**Class 1 Permit Modification Notification**

**Construction of a Roof Within the Parking Area Container Storage Unit**

**Waste Isolation Pilot Plant  
Carlsbad, New Mexico**

**WIPP HWFP #NM4890139088-TSDF**

Figure F-1  
WIPP Surface Structures

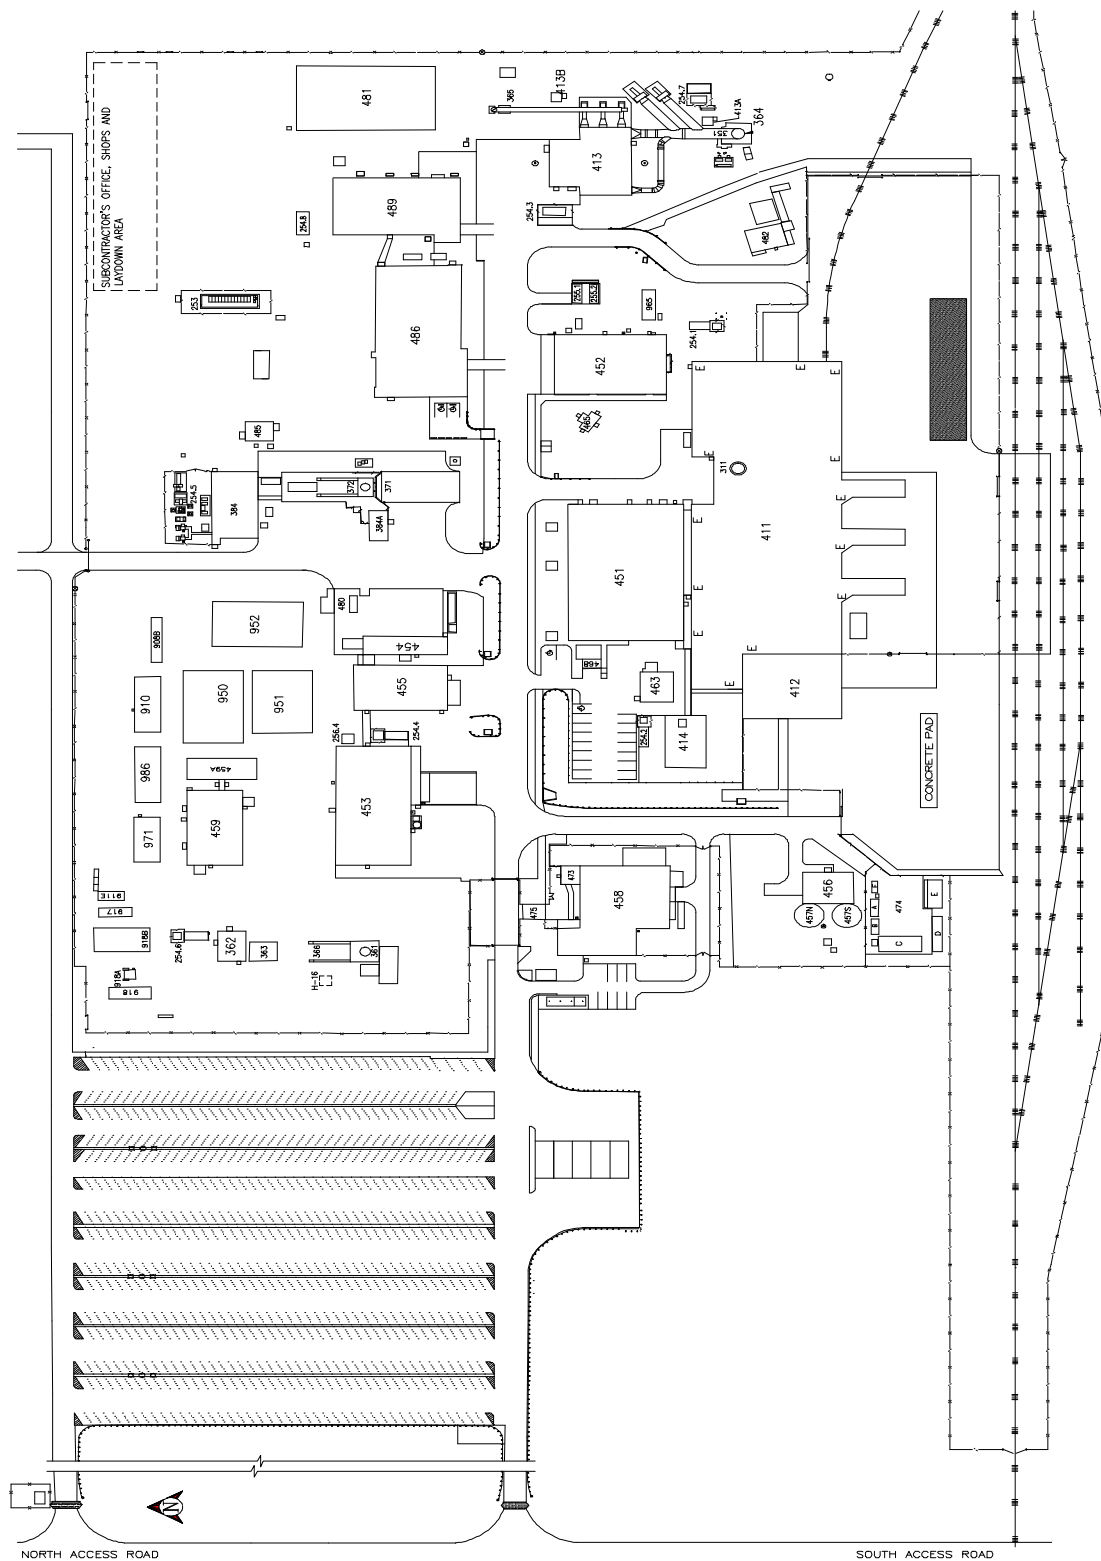
- a. 1. Figure F-1 has been revised
- a.2 Figure F-6 has been revised
- a.3 Figure F-8 has been revised
- b.1 Figure G-2 has been revised
- c.1 Figure M1-2 has been revised
- d.1 Figure O3-4 has been revised

(The PAU roof is indicated on the figures as a rectangle in the southeast corner of the PAU)

Parking Area Unit - Roof

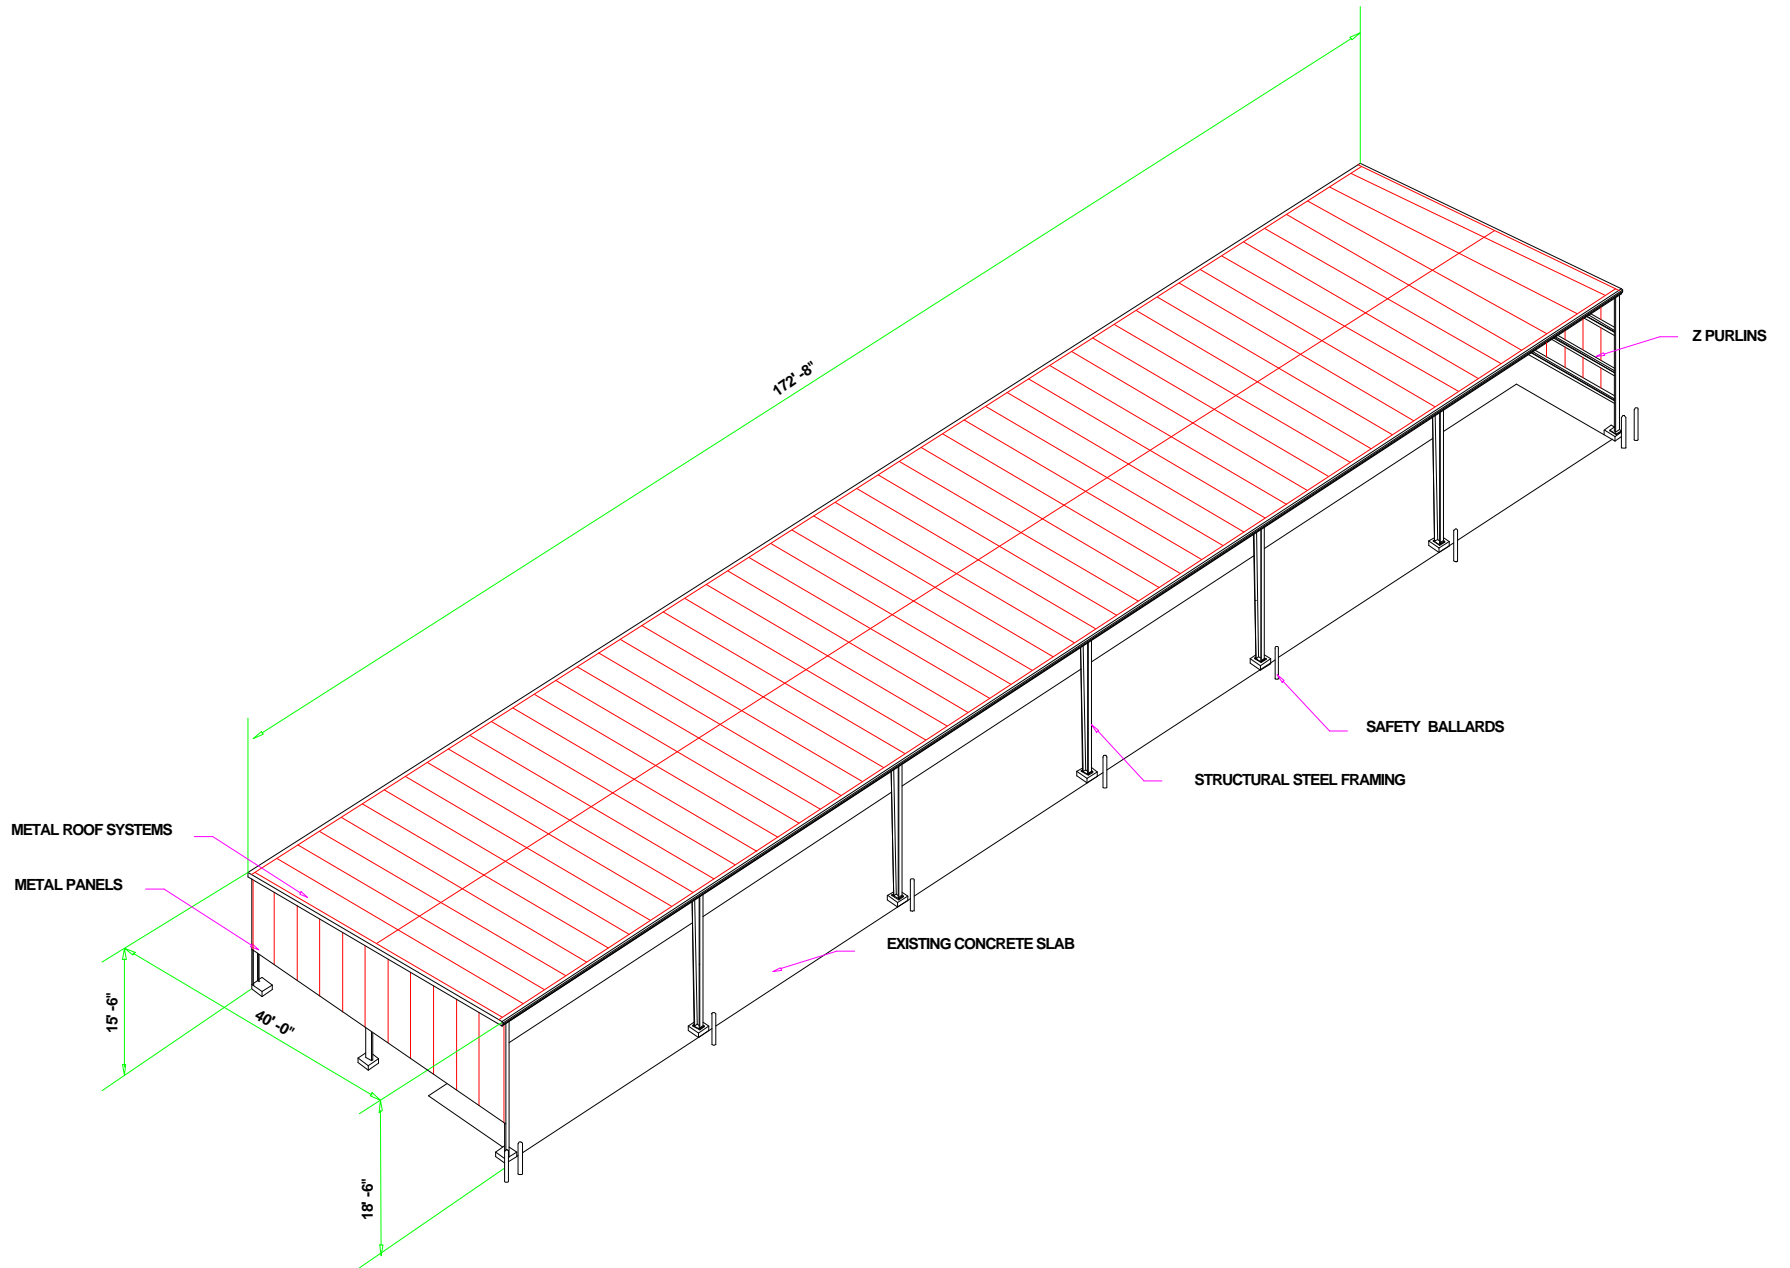
The roof will be approximately 170 feet in length, approximately 40 feet deep which is the length of the existing concrete pad in the PAU. The roof will be approximately 19 feet high to accommodate a trailer with TRUPACT-IIs. Tractors, trailers, empty and loaded CH Packages, forklifts, and other equipment currently used in the PAU may be stored under the roof structure. A diagram of the roof is included in Attachment B of this PMN. The “as built” drawings will be included in the Operating Record.
